# SITE PLAN

14150 Herring Rd  
Colorado Springs, CO 80908  
Parcel ID: 5205101010  
Lot area: 14.66 Acres  
Paper Size: 11"x17"  
Legal Description: Lot 6  
Wildwood Ranch Estates Fil 2  
Plat: 2453  
Zone: RR-5

File Number:  
PPR249

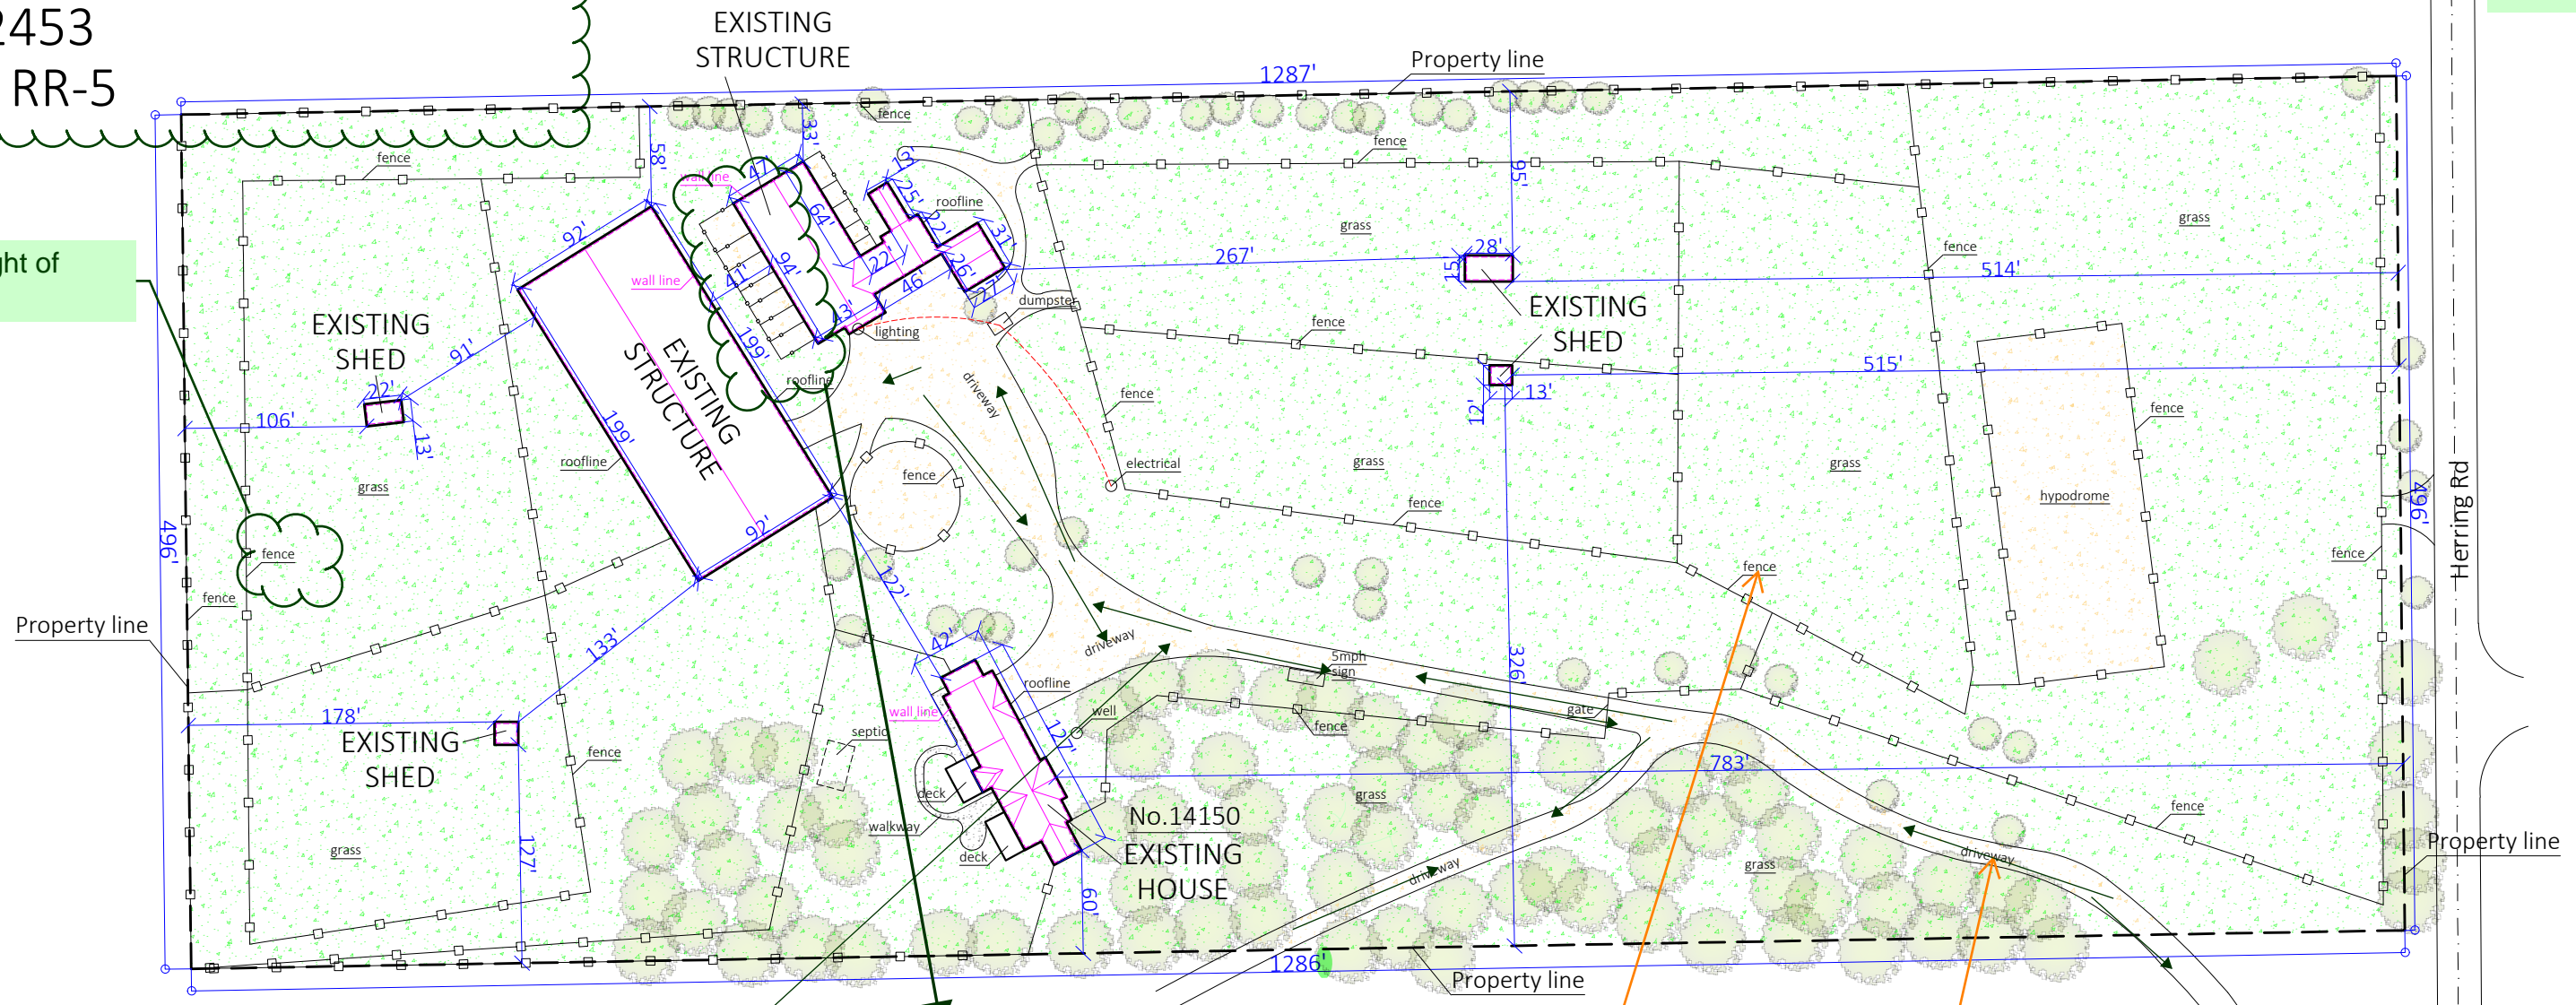
Please add:  
-name of applicant  
-lot size (14.66 acres)  
-total gross building sq footage (all of the buildings sq footage added up)  
-lot area coverage %  
-open space and impermeable space %

EPC STORMWATER REVIEW COMMENTS  
IN ORANGE BOXES WITH BLACK TEXT

Provide a note stating:  
"Per the County GIS, Floodplain X was found at  
the property, and there are no floodplain  
concerns"

Include date  
associated with  
when revisions

EX:  
"4/12/24  
Revisions"

Provide height of  
fencing

Label as "parking  
Spaces"  
-include ADA spot

Please depict:  
traffic circulation in and off the  
property

please label fences and driveway as existing, or  
provide a general note clarifying that what is  
shown is all existing. If there are any proposed  
improvements please clearly identify.
